Docket Number:	23-AFC-01
Project Title:	Morton Bay Geothermal Project (MBGP)
TN #:	255704
Document Title:	Hudson Ranch Power 1 Comments - Morton Bay Geothermal Project Resource Adequacy Questions
Description:	N/A
Filer:	System
Organization:	Hudson Ranch Power 1
Submitter Role:	Public
Submission Date:	4/15/2024 11:03:08 AM
Docketed Date:	4/15/2024

Morton Bay Geothermal Project Resource Adequacy Questions

GRG's Preliminary Questions on GeothermEx's Model Report

Figure 2.2 History Matching of Reservoir Pressure Data

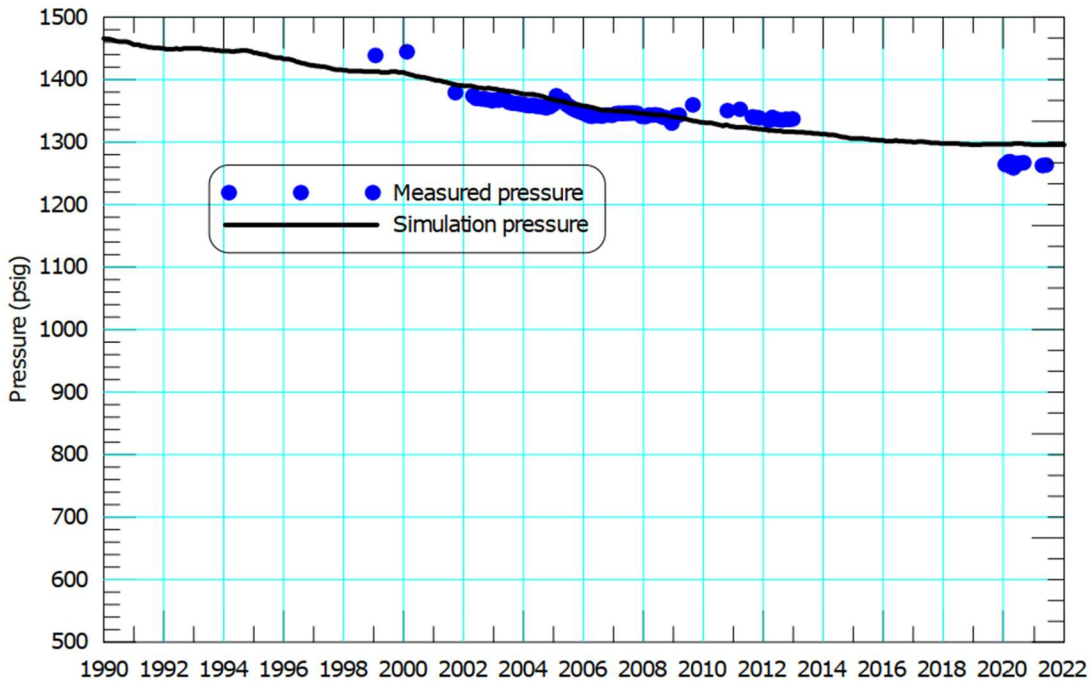
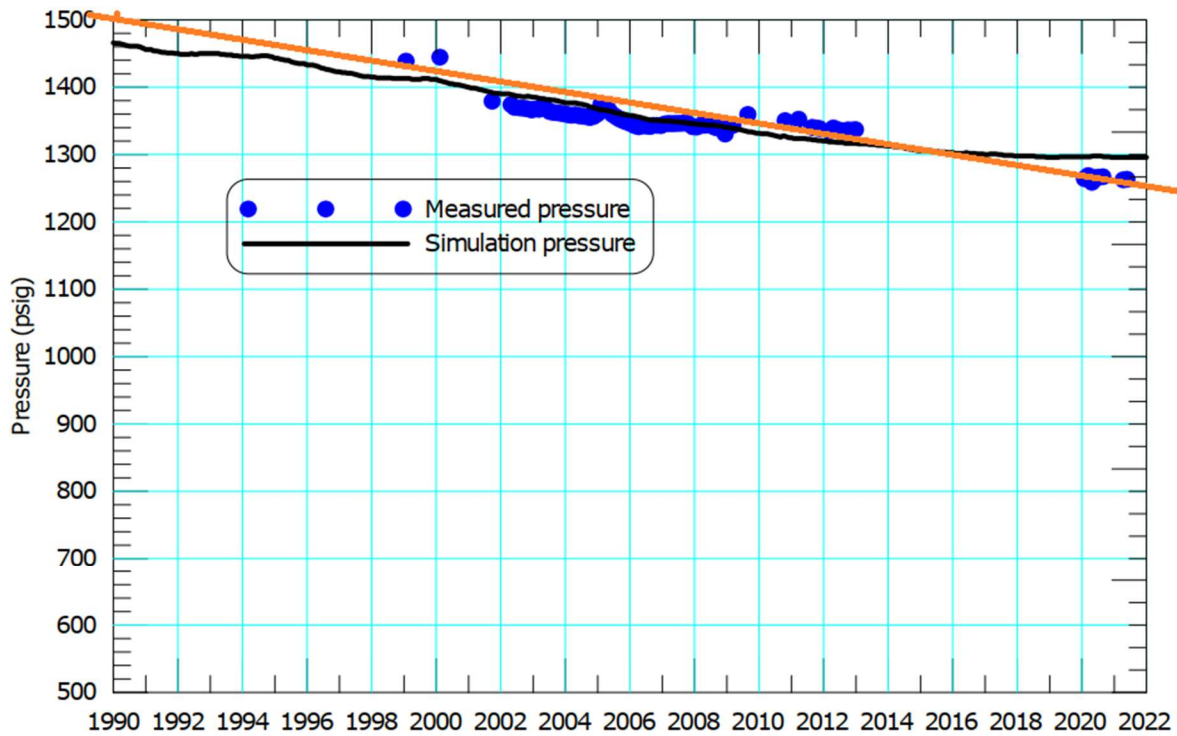
Figure 2.2 History match to “Reservoir Pressure” appears to be optimistic

- Issue: The simulated history match in Figure 2.2 (the black line) appears to level off after 2018 while the data (the blue dots) appear to continue a linear decline with no stabilization. See the figure below with the added orange line with a continuous trend, which appears to match the data better than the black line
- This is likely caused by either too high overall permeability in reservoir and/or too much pressure-dependent recharge coming in to the model. This will likely result in an optimistic forecast of pressure decline and actual pressure decline will be higher than predicted causing more decline in production.

Figure 3.1 Forecast of Reservoir Pressure

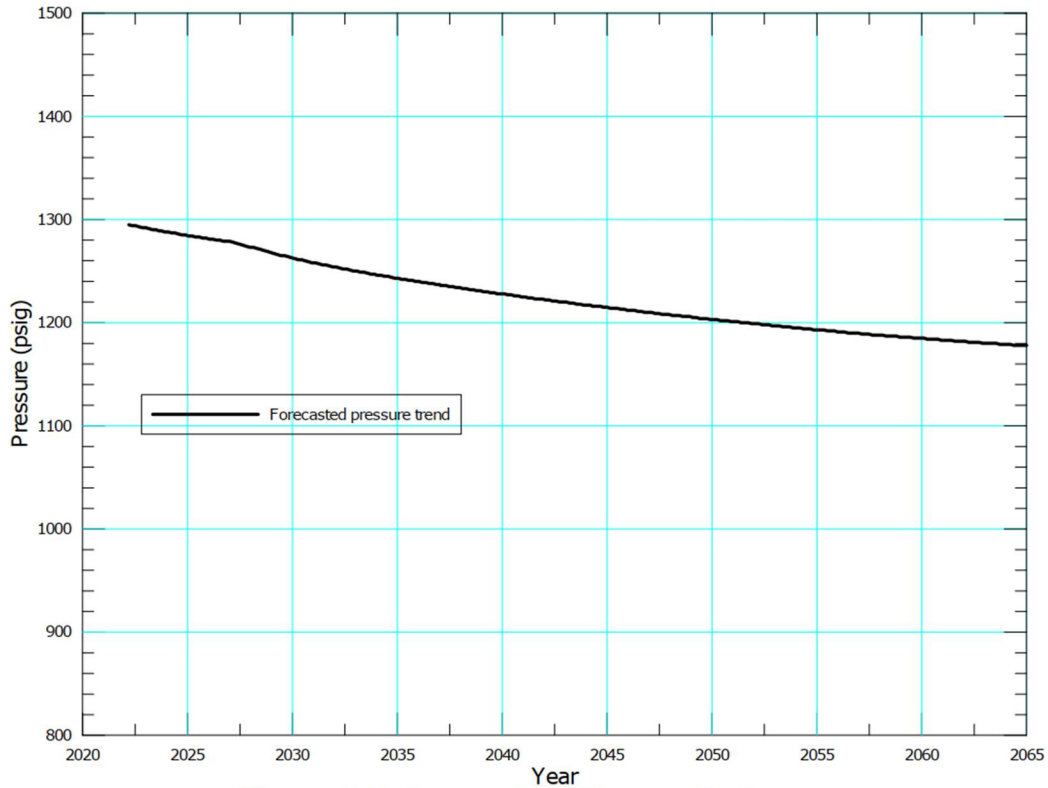
- Figure 3.1 shows an incremental 100 psi of reservoir pressure decline for an incremental 407 MW of additional production, which is half the pressure decline from the original 350 MW. This supports the conjecture that the location of the reservoir pressure point is not near HRP and pressure decline near HRP will likely be much more than an incremental 100 psi, which is already enough to affect flow rates.

Figure 3.4 Forecast of Enthalpy, TDS, and NCG for Morton Bay

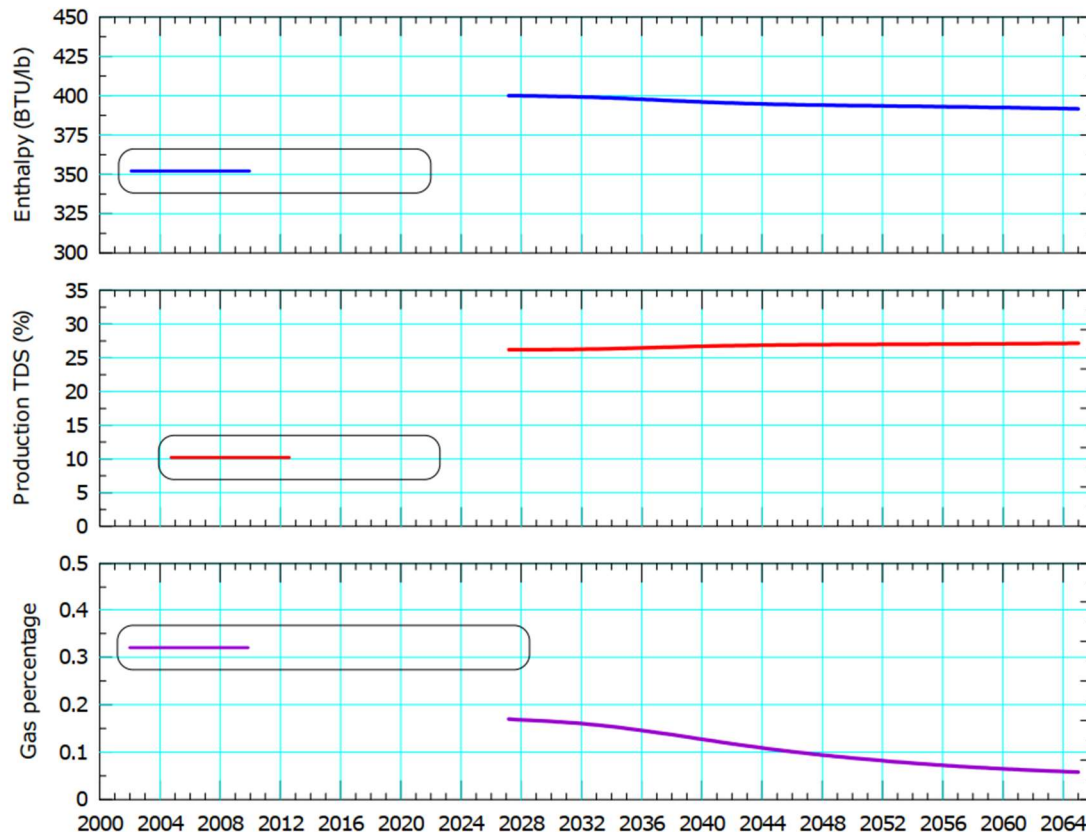
Figure 3.4: Forecast of Enthalpy, TDS, and NCG for Morton Bay

- Issue: This forecast leaves out the forecast of reservoir pressure in the region of Morton Bay, the forecast also leaves out a forecast of power generation, which the report repeatedly claims to do.
- This forecast was conducted by placing the Morton Bay production wells on set flow rate constraint and the simulator calculated what would happen in the reservoir *if those flow rates were maintained*.
- Even with the above caveat, the enthalpy does show a decline, so strictly speaking the power generation would decline
- Reservoir pressure in the Morton Bay region combined with wellbore simulation would be required to estimate the true decline rate and thus how many makeup wells are needed.
- Depending on how many make up wells are needed, and where they are placed, this could potentially further negatively affect HRP

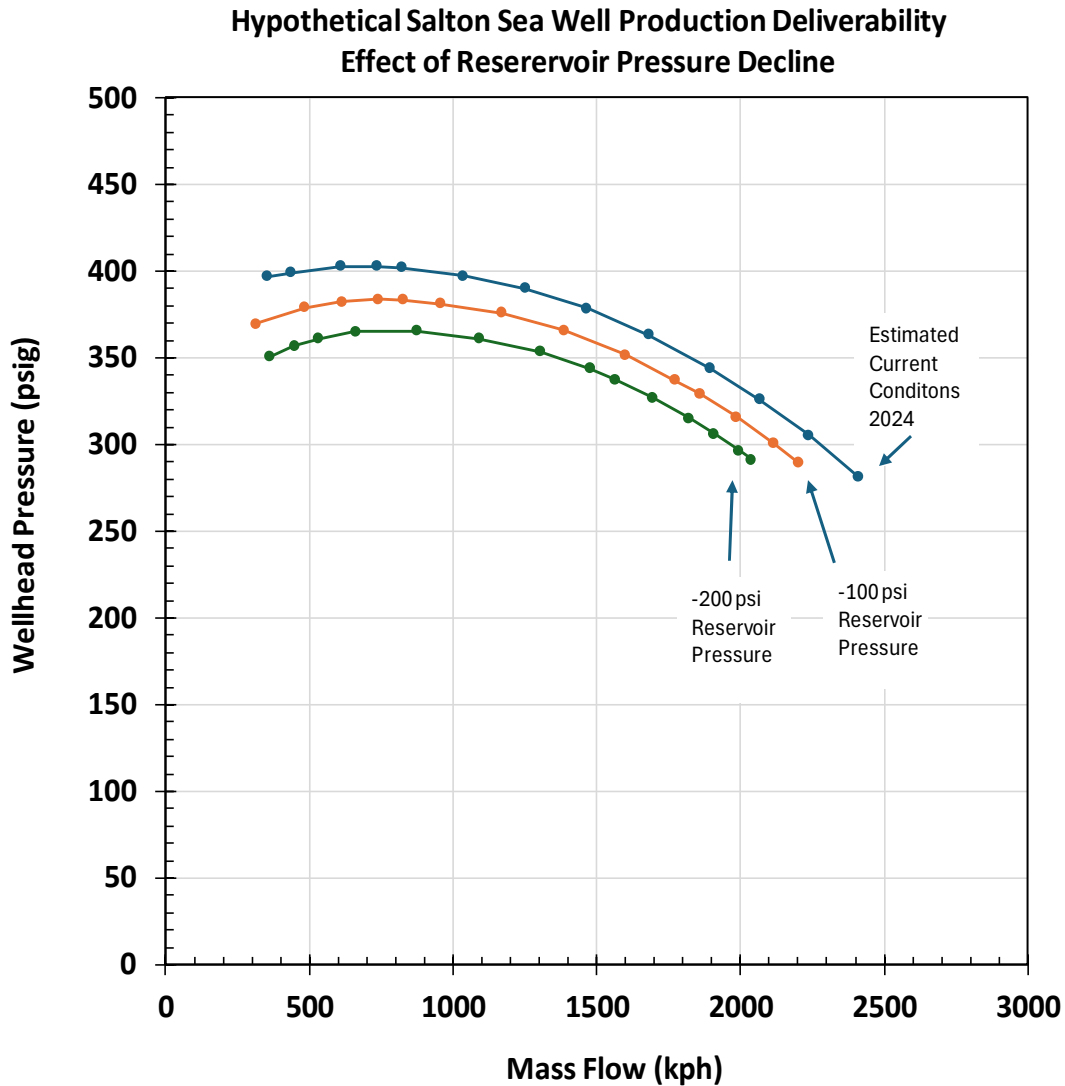
Page 3.2 Overall: In conclusion, the resource adequacy study has demonstrated that the geothermal resource can accommodate both existing geothermal power plants and the proposed geothermal power plants (Black Rock, Elmore North, and Morton Bay) over the horizon of the evaluation (through 2065).

- Issue: It is agreed that the simulation study has shown that there are sufficient heat and mass reserves to support the additional production. However, it is not clear if the simulation included a potential expansion by Cyrq, which would likely have an impact on both Cyrq and BHER production rates.

- Pressure Decline: No predicted pressures in Morton Bay or HRP were shown. The study has not demonstrated that the pressure decline HRP is modest and the model likely underpredicts the future pressure declines across the whole model due to the mismatch in reservoir pressure in 2022 where the model shows stabilized pressure, but the data show continued decline.

- Temperature Decline: No temperature declines in HRP were shown. The study has not demonstrated (or shown) that enthalpy decline in HRP will be modest. The use of quite large grid blocks in and around HRP is likely to underpredict the temperature decline.
